NO.	REVISION	DATE	BY
5	ADDENDUM NO.3	Jan. 18, 2008	
4	ADDENDUM NO.2	Jan 9, 2008	
3	ISSUED FOR TENDER	Nov 2007	
2	ISSUED FOR FINAL REVIEW	6 July 2007	
1	ISSUED FOR REVIEW	7 May 2007

PROJECT TITLE
NOTRE DAME COMMUNITY CENTRE RENOVATION
271 AVE. DE LA CATHEDRALE
WINNIPEG, MANITOBA

SHEET TITLE
**ELEVATIONS
PHASE 1**

DRAWN BY	SCALE	SHEET NUMBER
MJ	3/16" = 1'-0"	A-6.0
CHECKED BY	DATE	
EC	15 Oct. 2007	
PROJECT NUMBER	REVISION	
06-012

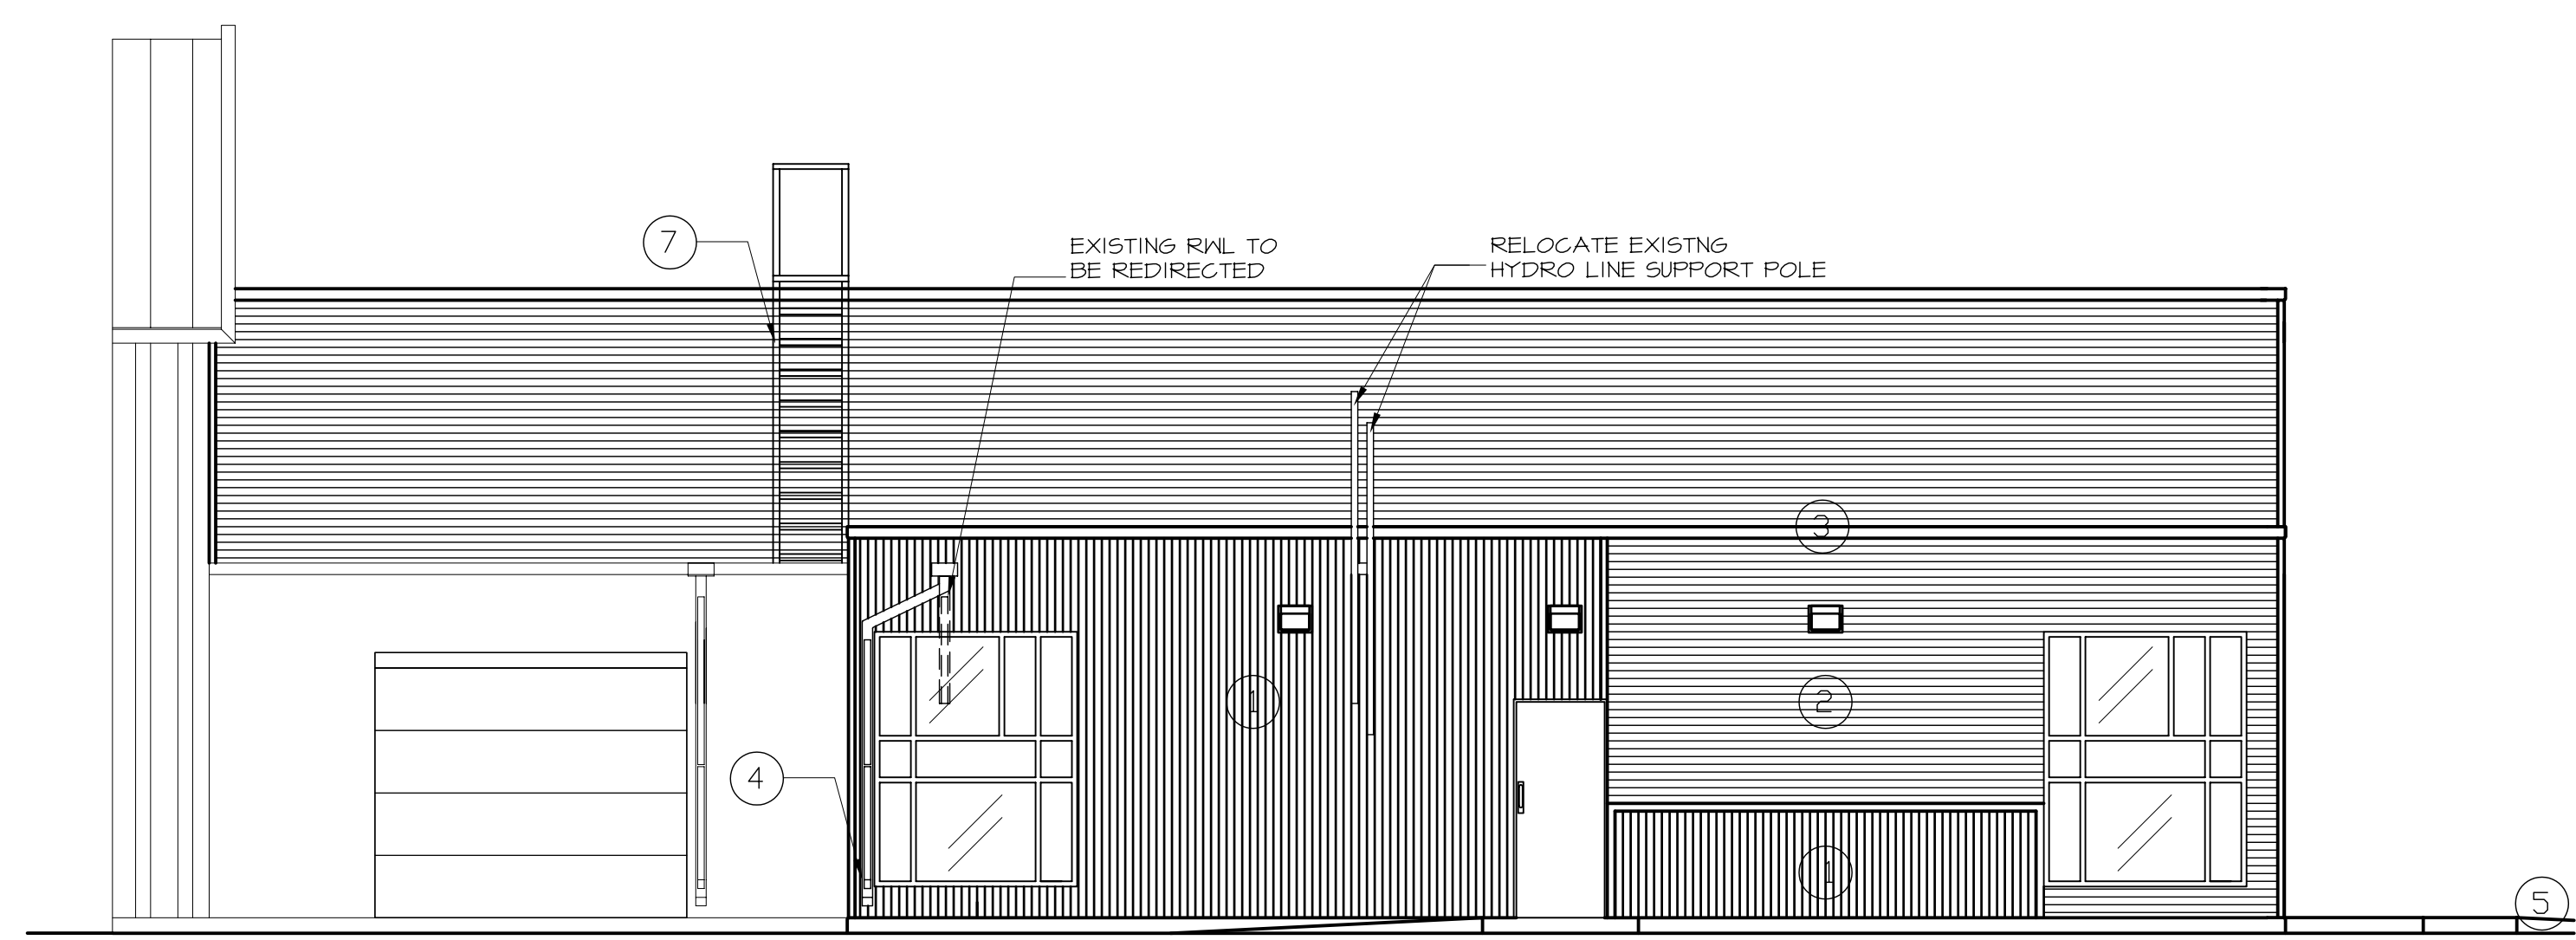
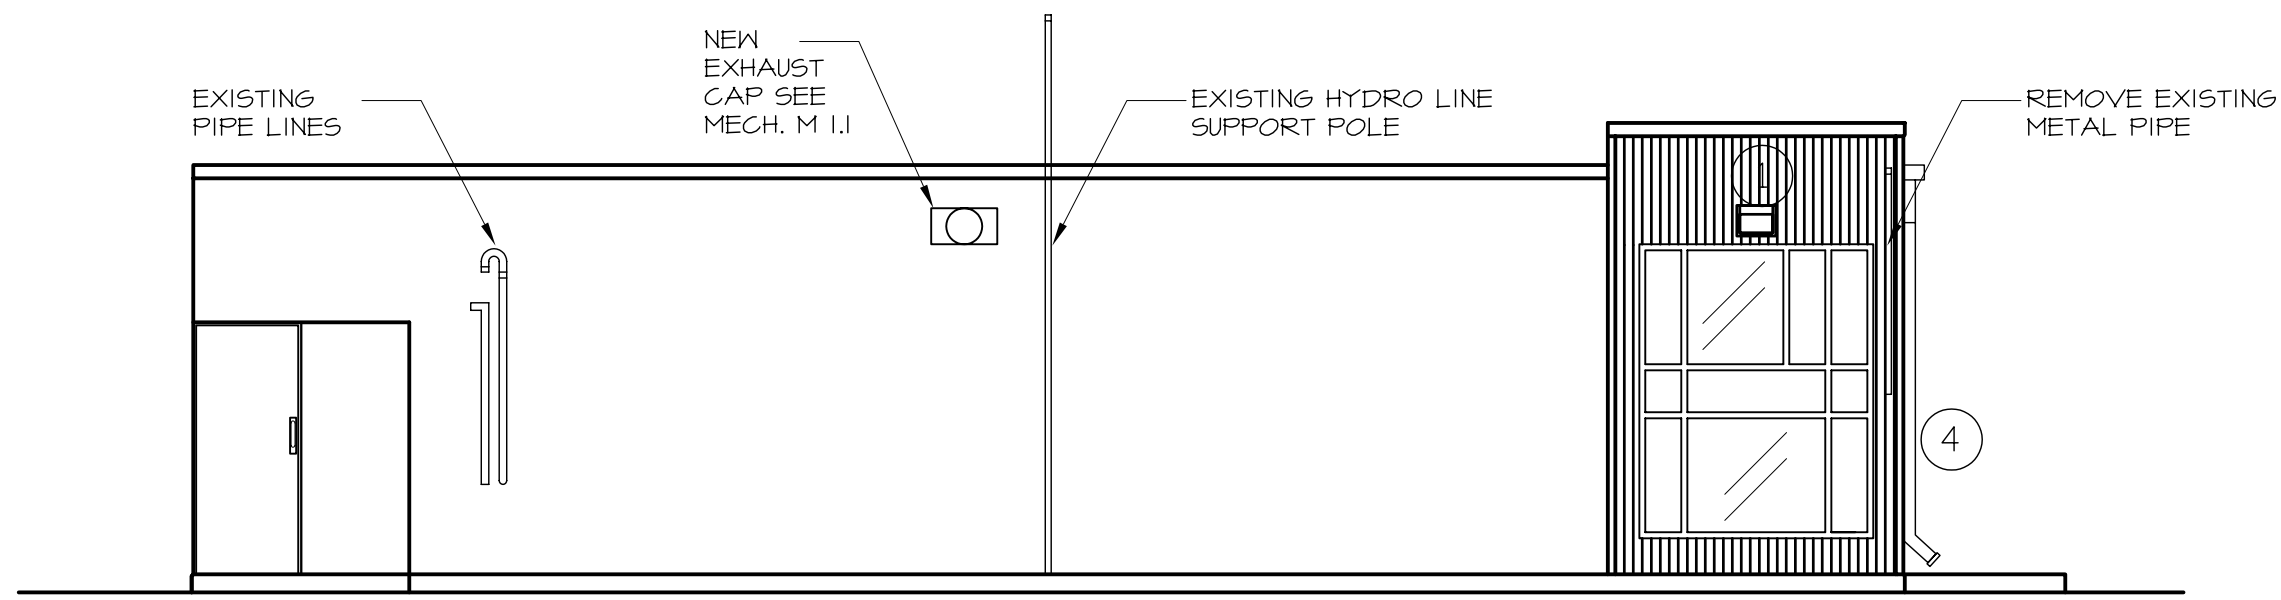
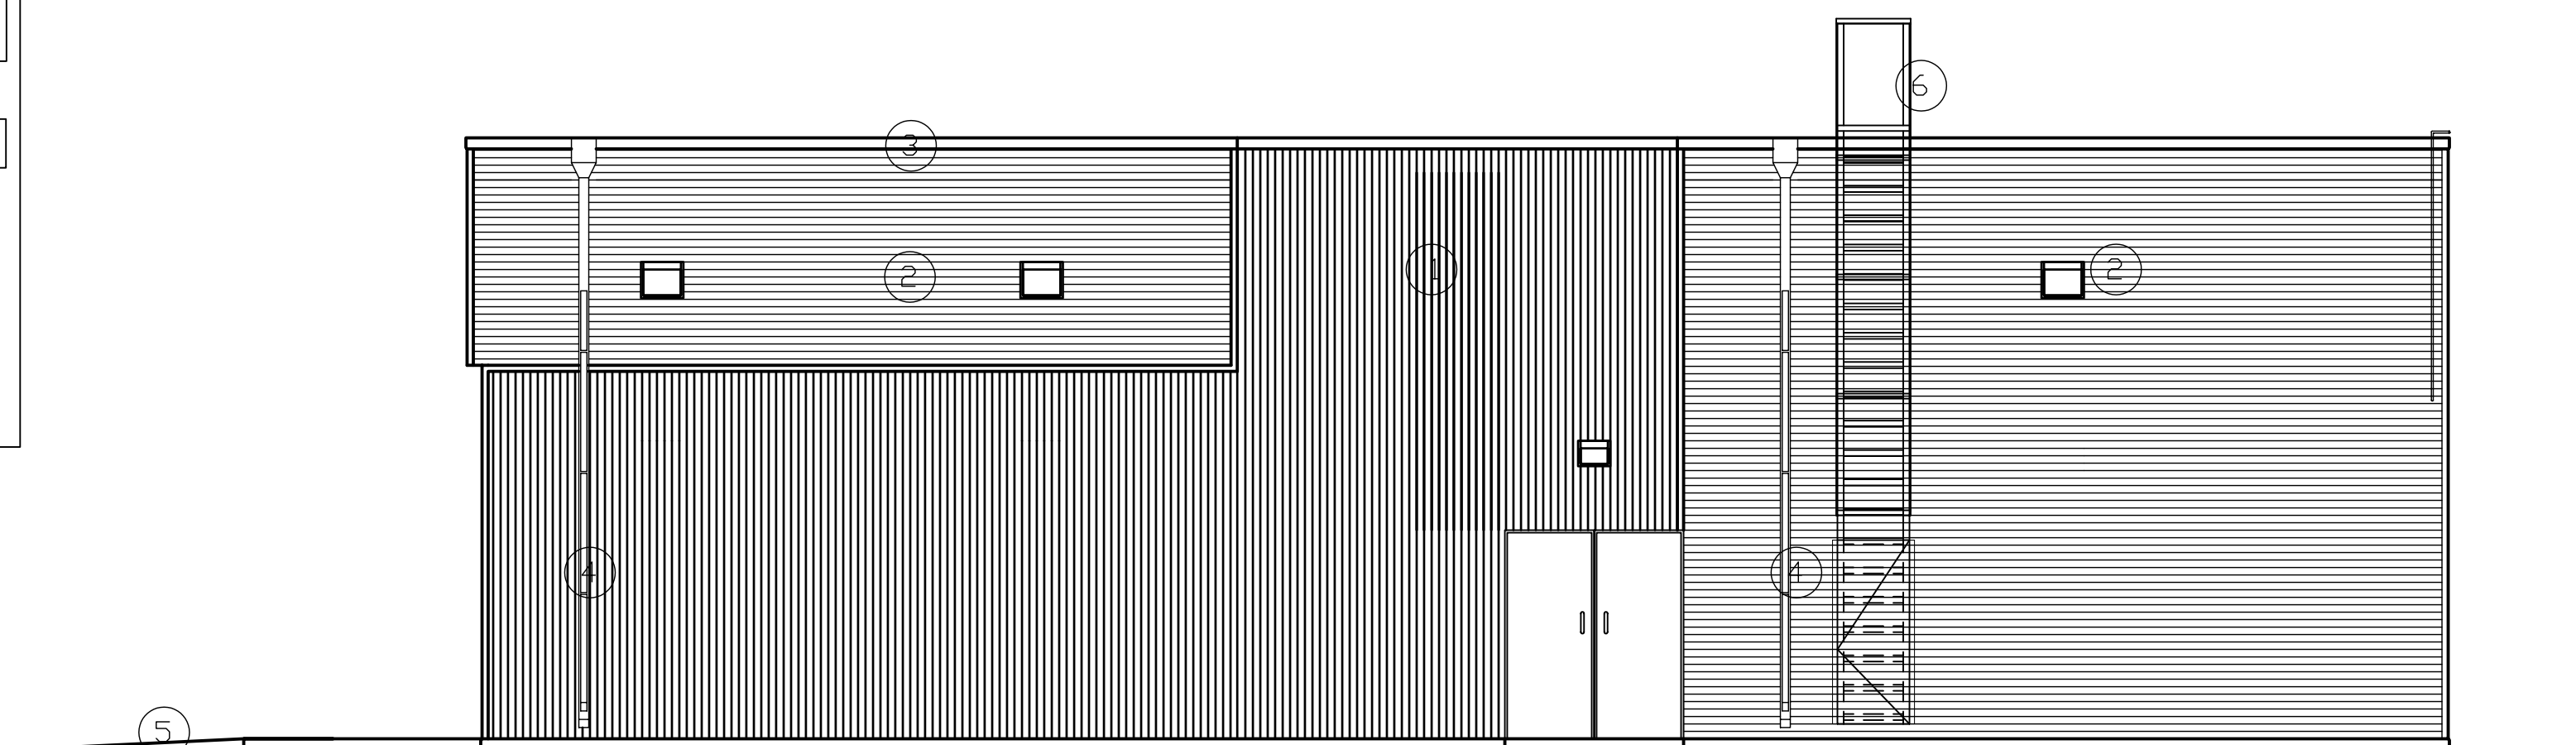
- Revision: 5
WALL LEGEND
- 1 VICREST® CL622R VERTICAL METAL PANELS
ON REVISION: 2" VARIOUS FURRING CHANNELS QC5710
TERRA COTTA
 - 2 VICREST® CL622R HORIZONTAL METAL PANELS ON 6"/5"
FURRING CHANNELS REVISION: QC3654 SAND BEIGE
 - 3 PREFINISHED METAL CAP FLASHING VICREST®
COLOUR V16010 TILE RED REVISION: QC3654
SAND BEIGE
 - 4 RAIN WATER LEADER VICREST® COLOUR V16010 GOLD
SAND BEIGE REVISION: QC3654
 - 5 GRADED WALKWAY
 - 6 LADDER SEE
DETAIL A1.1/1 & 2
 - 7 LADDER SIM. TO
DETAIL A1.1/1 & 2
WITHOUT HOOP CAGE
AND LOCKABLE
DOOR
